## SUBDIVISION AUTHORITY MINUTES

### MEETING NO. 47

REVISION of conditionally approved tentative plan of subdivision to create 163 residential lots, one (1) multi-unit housing lot (MHL), and two (2) Municipal Reserve lots, from Lot 4, Block 1, Plan 212 2367, and Lot 1, Block 1, Plan 112 3855 located south of 177 Avenue NW and west of 66 Street NW;  
**CRYSTALLINA NERA**

RE: REVISION of conditionally approved tentative plan of subdivision to create 163 residential lots, one (1) multi-unit housing lot (MHL), and two (2) Municipal Reserve lots, from Lot 4, Block 1, Plan 212 2367, and Lot 1, Block 1, Plan 112 3855 located south of 177 Avenue NW and west of 66 Street NW; **CRYSTALLINA NERA**

## SUBDIVISION CONDITIONS OF APPROVAL MAP

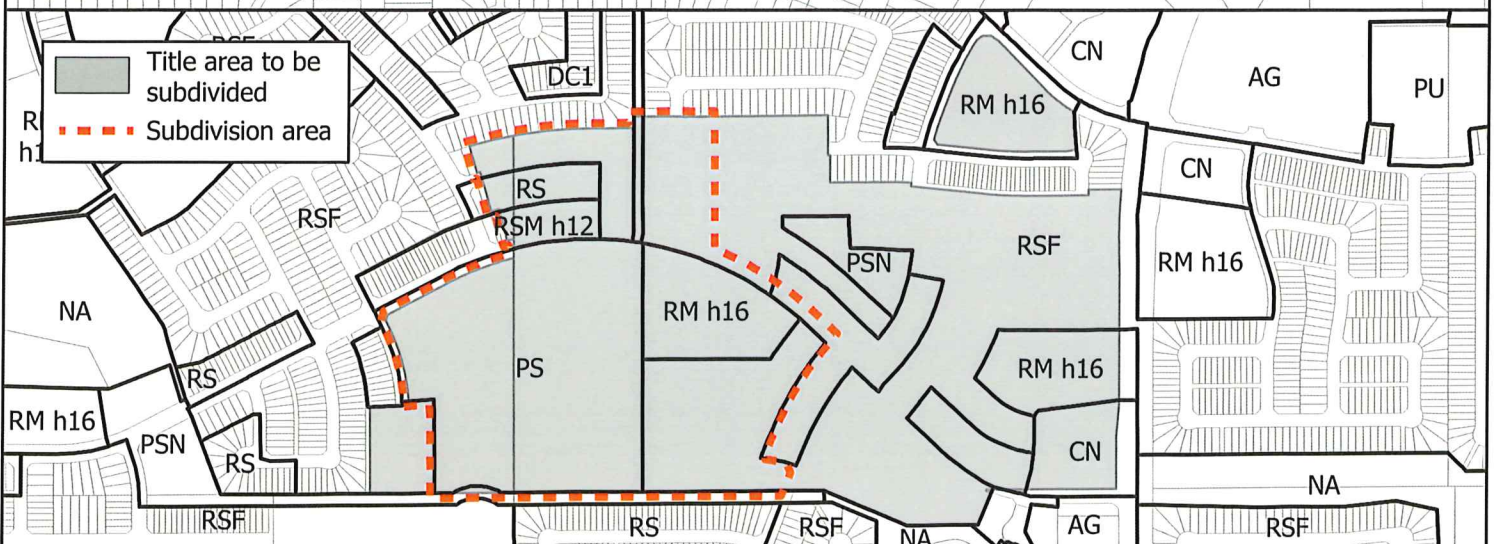
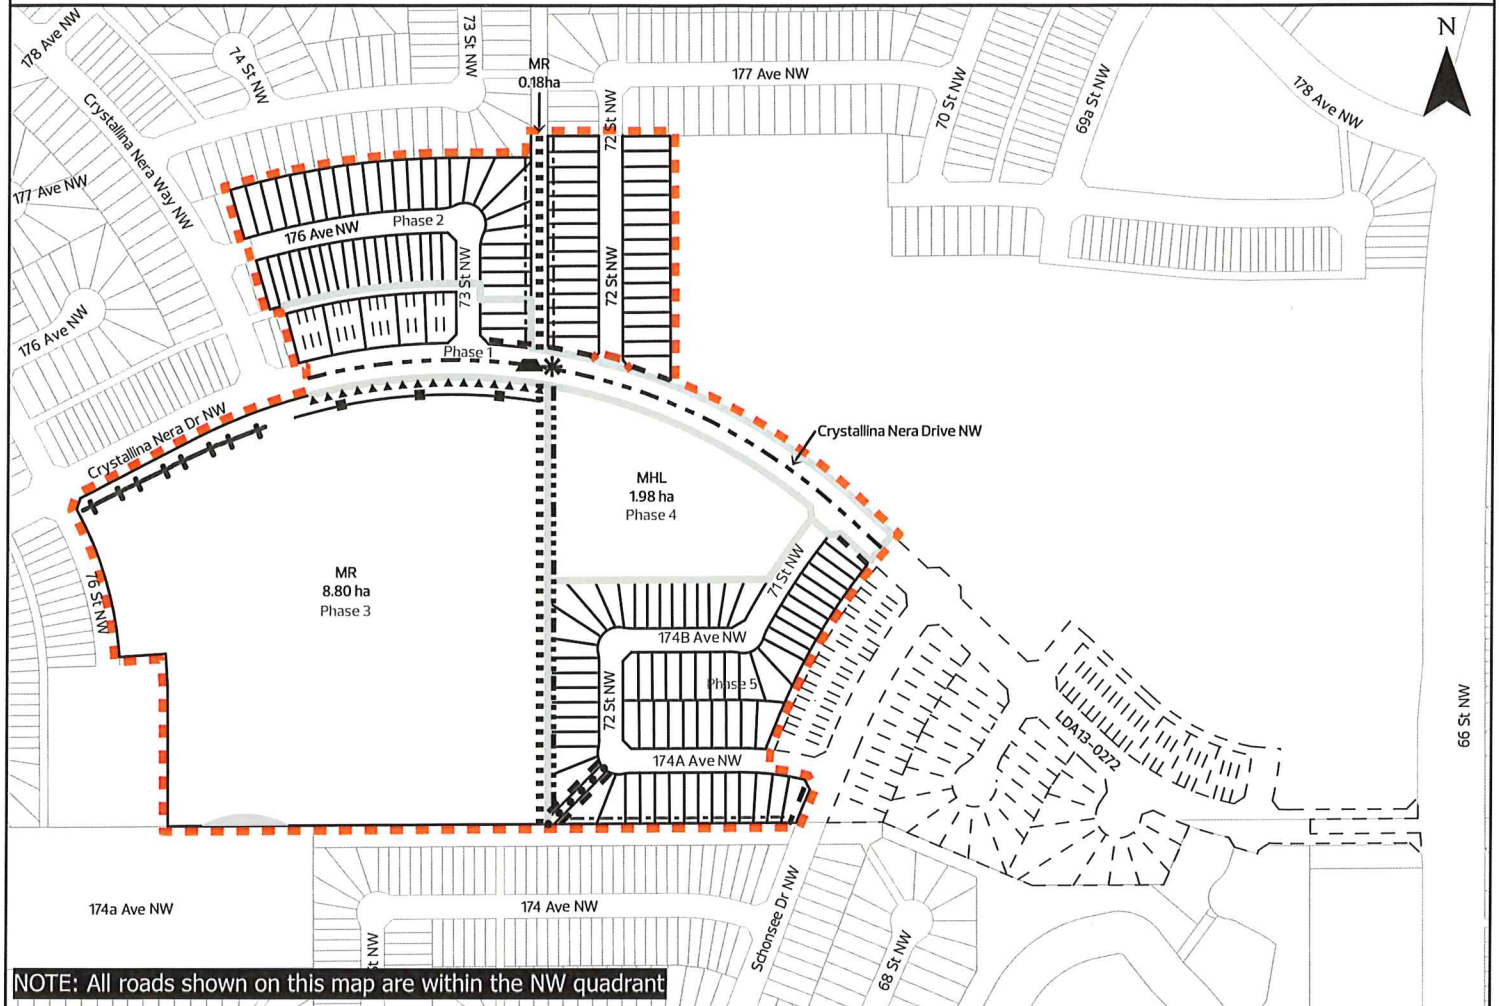
4. that the subdivision Phase 1 boundary be amended to include the dedication of the full intersection of Crystallina Nera Drive NW and 72 St NW, to the satisfaction of Subdivision and Development Coordination, as shown on the "Conditions of Approval" map, Enclosure I;

9. that the owner construct Crystallina Nera Drive NW to a transit collector roadway standard, to the satisfaction of Subdivision and Development Coordination, as shown on the "Conditions of Approval" map, Enclosure I;

10. that the owner construct a 3 m hard surface shared use path with "Shared Use" signage, lighting, and bollards, within the school/park site and the 0.18 ha MR lot, to the satisfaction of Subdivision and Development Coordination, as shown on the "Conditions of Approval" map, Enclosure I;

11. that the owner construct a 2.5 m mono-walk with straight faced curb and gutter to the satisfaction of Subdivision and Development Coordination, as shown on the "Conditions of Approval" map, Enclosure I;

12. that the owner construct a 1.8 m concrete sidewalk with lighting and bollards within the walkway, with connections to adjacent paths, to the satisfaction of Subdivision and Development Coordination, as shown on the "Conditions of Approval" map, Enclosure I;

14. that the owner pay for the installation of Rectangular Rapid Flashing Beacon, as shown on the "Conditions of Approval" map, Enclosure I. The City of Edmonton shall complete the signal design, and the City's Electrical Services Contractor must install the traffic control device as per the agreement between the City of Edmonton and the Electrical Services Contractor. The timing of the traffic control device installation will be at the direction of City Operations. If traffic signals are not deemed warranted by City Operations within 5 years of signing the Servicing Agreement, the owner will be required to provide payment to the City of Edmonton for the installation of traffic signals at that time to fulfill this obligation;

16. that the owner construct all fences wholly on privately-owned land and the Municipal Reserve (MR) lot, to the satisfaction of Subdivision and Development Coordination, as shown on the "Conditions of Approval" map, Enclosure I;

17. that the owner provide naturalization landscaping within the MR parcel, to the satisfaction of City Departments and affected utility agencies, as generally shown on the "Conditions of Approval" map, Enclosure I; and

## SUBDIVISION CONDITIONS OF APPROVAL MAP

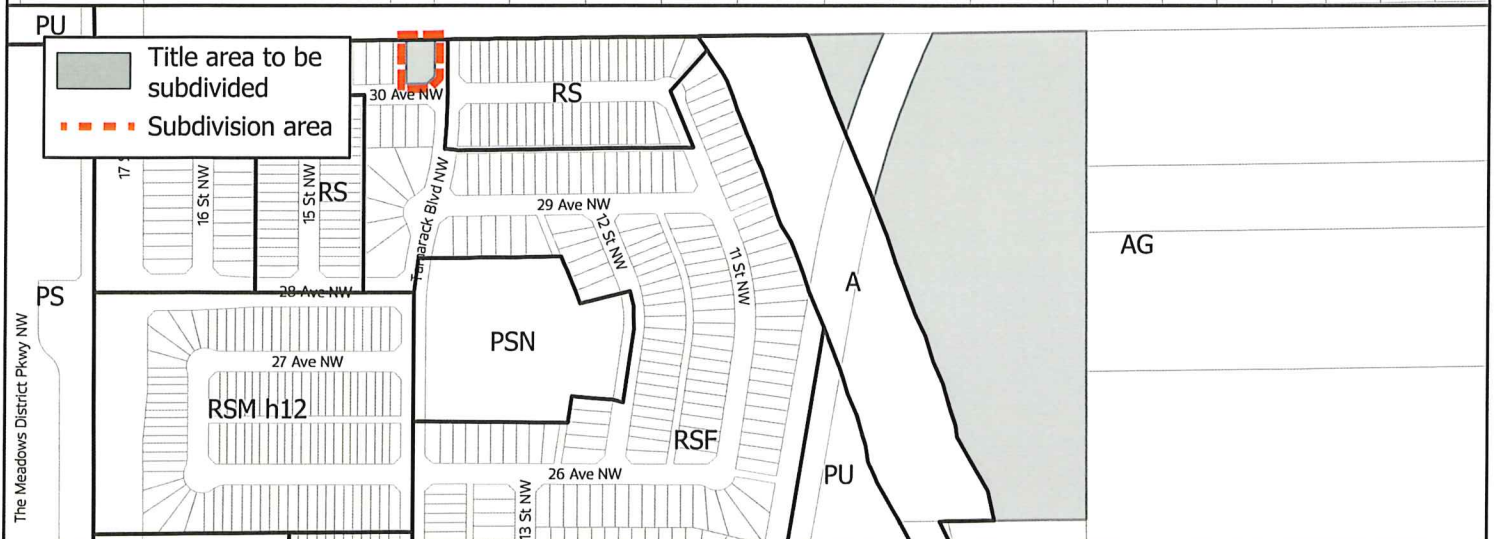
4. that the owner remove the road structure of the existing temporary transit turnaround and construct permanent infrastructure which may include but are not limited to curb and gutter, curb ramp, and 1.8 m concrete sidewalk and signage and barriers on the west side of Tamarack Boulevard NW, as shown on Enclosure I. All costs associated with the removal of the road structure, re-grading of the land, landscaping and any utility relocation / modification deemed necessary as a result of the removal will be the responsibility of the owner. Details relative to this requirement will be reviewed with the submission of detailed engineering drawings;

5. that the owner construct all fences wholly on privately-owned land, to the satisfaction of Subdivision and Development Coordination, as shown on the "Conditions of Approval" map, Enclosure I; and

# TENTATIVE PLAN

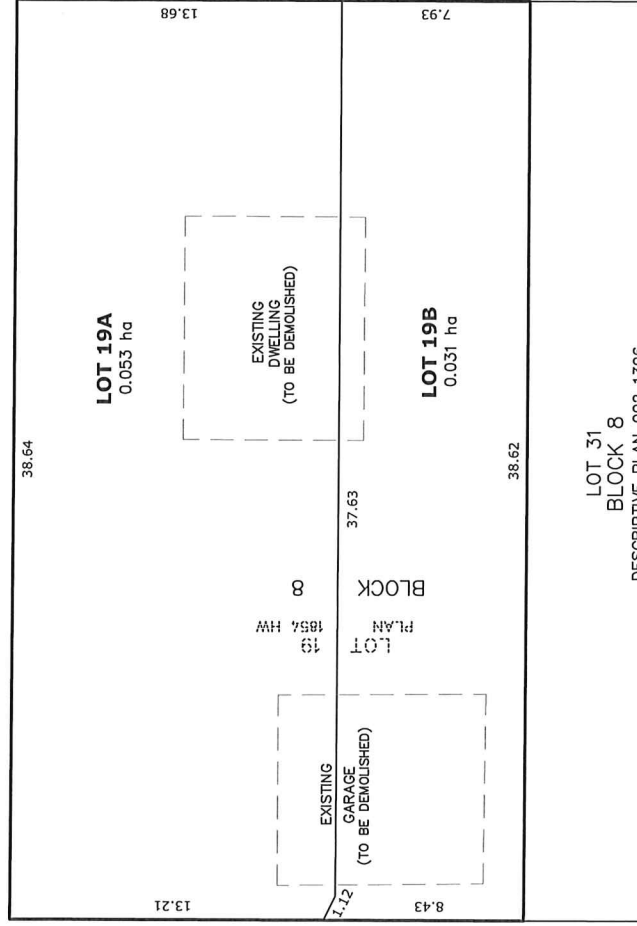
- Access for future development must be to the adjacent alley as per the General Regulations (Section 6.1) in the 2.10 RS - Small Scale Residential Zone of Zoning Bylaw 20001.

- There is an existing access to 58 Street NW. Upon redevelopment of proposed Lot 19A, it must be removed. At that time, the owner/applicant will be required to obtain a Permit for the access' removal from the City's Development Services team. Apply online at [www.edmonton.ca/permits](http://www.edmonton.ca/permits).

- There are existing concrete steps that encroach into the 58 Street NW road right of way. They must be removed or the owner must enter into an Encroachment Agreement with the City of Edmonton. Email [encroachmentagreements@edmonton.ca](mailto:encroachmentagreements@edmonton.ca) for information.

- There is an existing power pole and guy wire that may interfere with access to proposed Lot 19B. Subdivision Planning recommends that the applicant/owner contact EPCOR Distribution & Transmission to confirm whether this pole will inhibit alley access to the site, which may result in a delay with the issuance of the Development Permit. Contact EPCOR Customer Engineering Services for more information ([ces@epcor.com](mailto:ces@epcor.com) or 780-412-3128).

# TENTATIVE PLAN

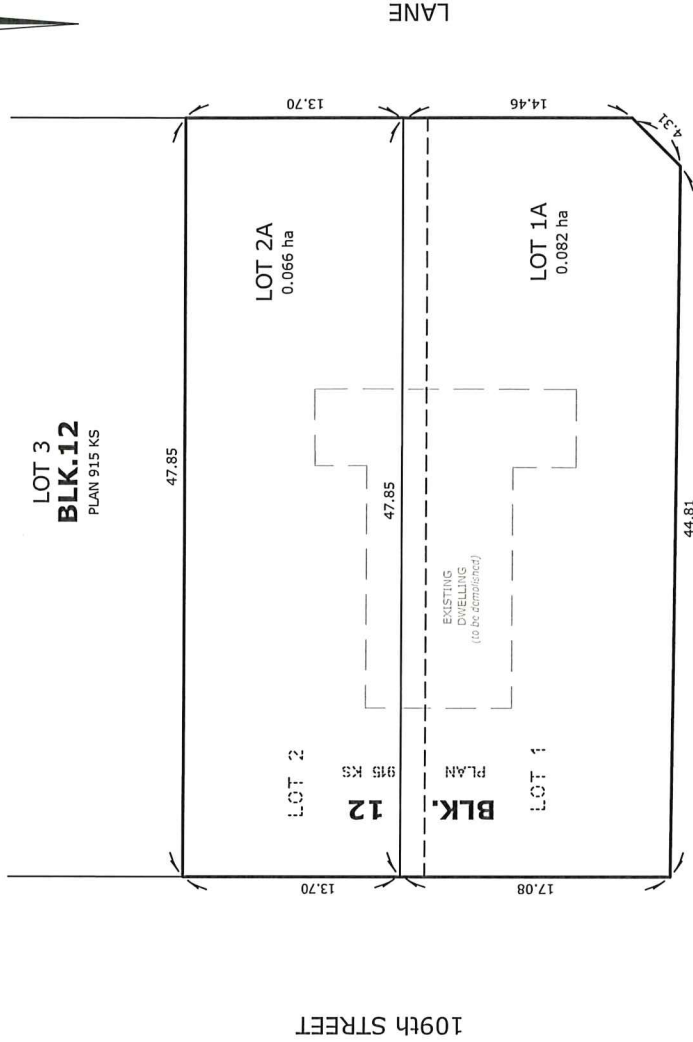
1. that the owner apply for a permit to demolish the existing dwelling and garage prior to endorsement of the final plan. Demolition permits can be obtained from Development Services. Apply online at [www.edmonton.ca/permits](http://www.edmonton.ca/permits); and
2. that the owner pay all outstanding property taxes prior to the endorsement of the plan of survey.
